CITY OF ALBUQUERQUE

RE: **FedEx Fuel Station**
Daytona Rd NW
Grading Plan Stamp Date: 7/16/18
Hydrology File: K09D026C

**RE: FEDEX FUEL STATION
DAYTONA RD NW
GRADING PLAN STAMP DATE: 5/29/18
HYDROLOGY FILE: K09D026C**

ENGINEER'S SEAL

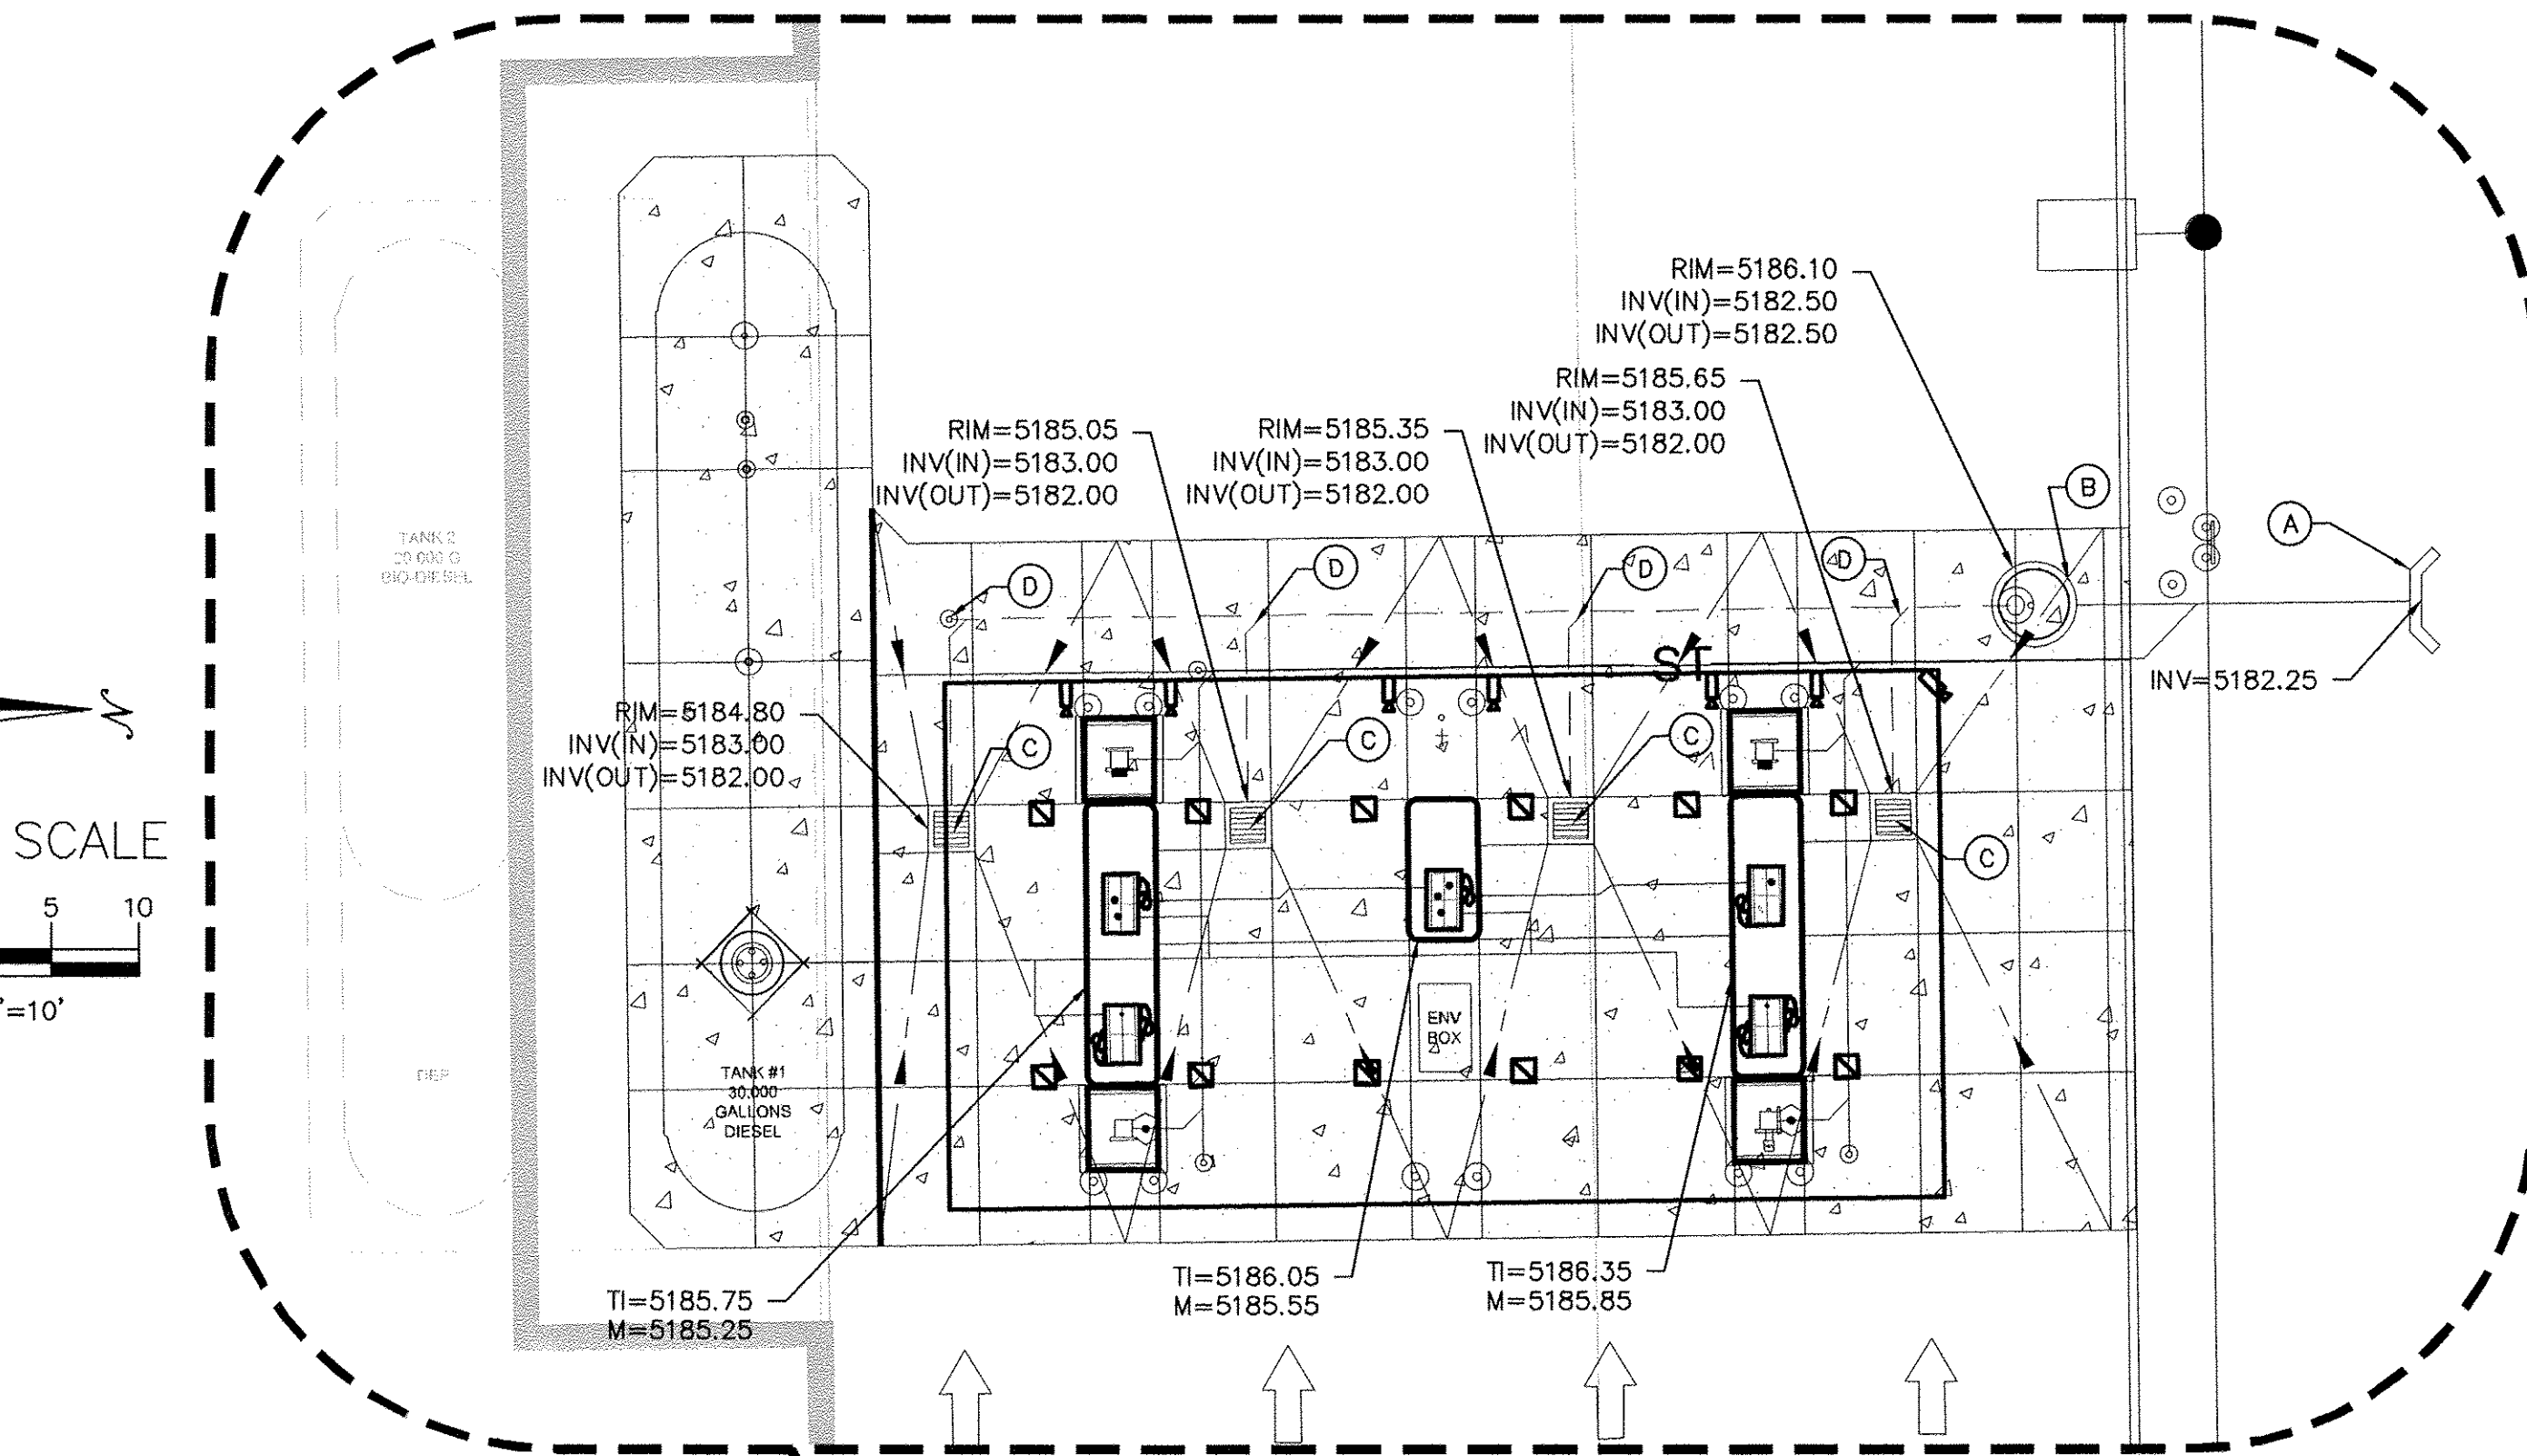
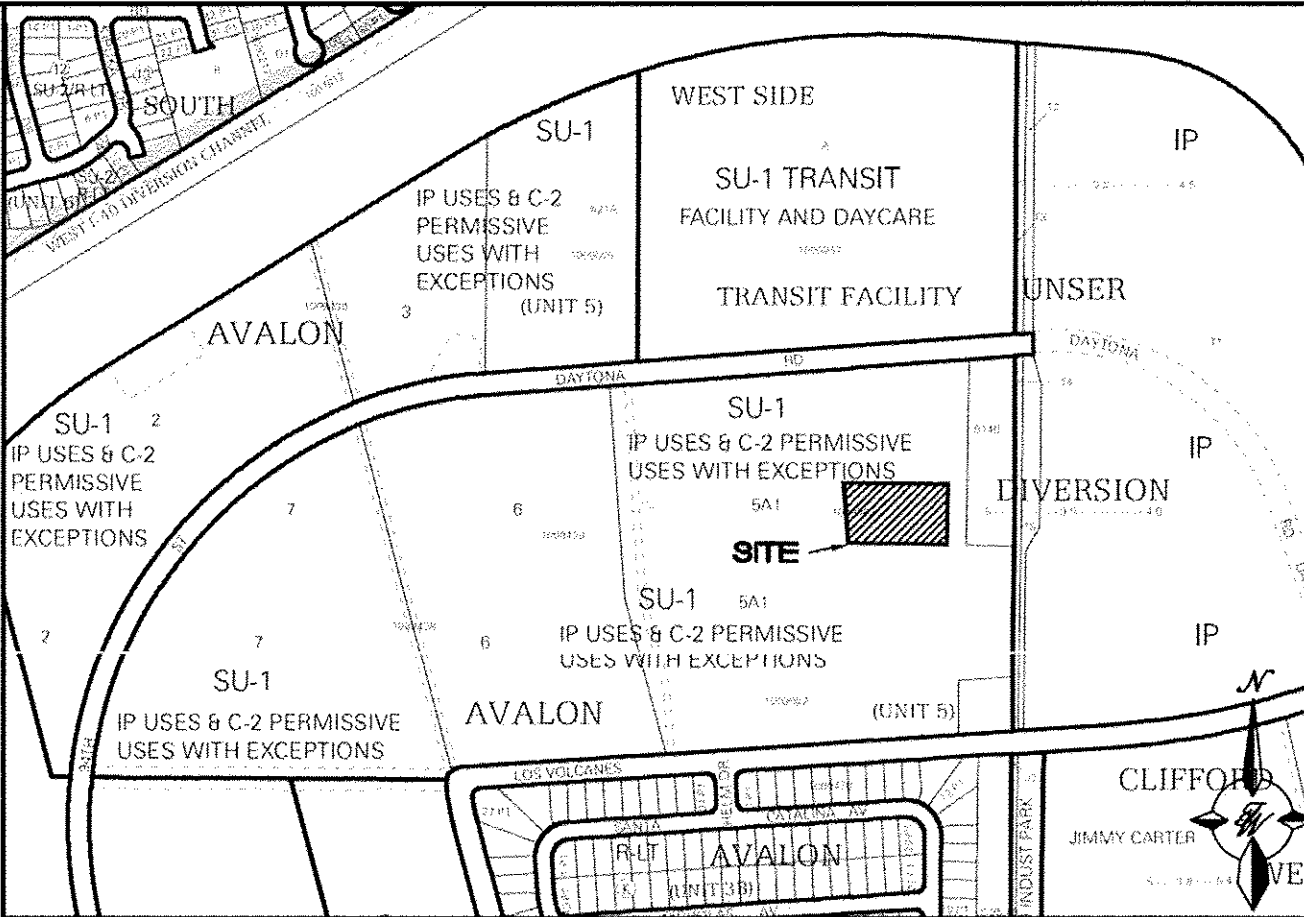
1. Include discussion of how the first flush is being retained on-site. Provide supporting calculations, drainage basin exhibits, etc. demonstrating that the area of new impervious (and redeveloped impervious, if any) will be routed to an adequately sized first flush facility.

Response: A paragraph discussing the first flush ponding was added to the grading plan. As noted in the original drainage report for the entire FedEx site, the detention pond was created with a first flush volume for all impervious areas, along with detention of developed flows. The volume of the desilting pond that will be moved to the north of the proposed fueling addition is not included in these permanent first flush and detention volumes.

| | | SHEET # GR-2 |

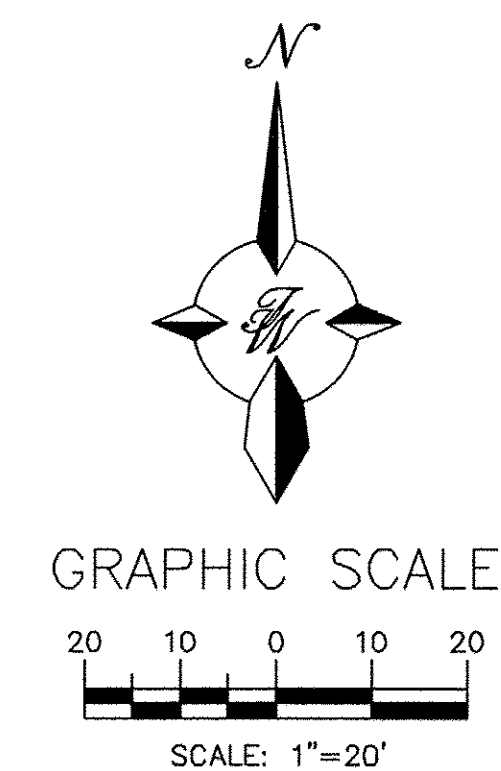
4. For fueling stations, demonstrate control of oil from vehicle parking areas per DPM Chapter 22.9.E, Table 1. The storm interceptor noted on sheet GR-2 appears to be intended for this, but it needs show that the parking area (around the fuel islands) is contained and drains to it. Please provide a specification for the storm interceptor and area inlets (notes B and C) as well.

Response: Run off from proposed parking areas at the fuel pumps will be routed to area inlets and through a storm interceptor and to the desilting pond that will be relocated to just north of the fuel island improvements. Ultimately, if this pond were to overflow, runoff would be routed to the detention Pond 5 (with first flush storage). If in the future they want to eliminate the desilting pond, the outfall from the Stormceptor can be routed to an existing storm drain inlet located in a landscaped area SE of the fueling area. The make and model of storm interceptor required and its capacities were added to the plan keyed note (Stormceptor, model # SC 450i). The area inlets were noted to be 2'x2' concrete inlets with traffic rated grates.
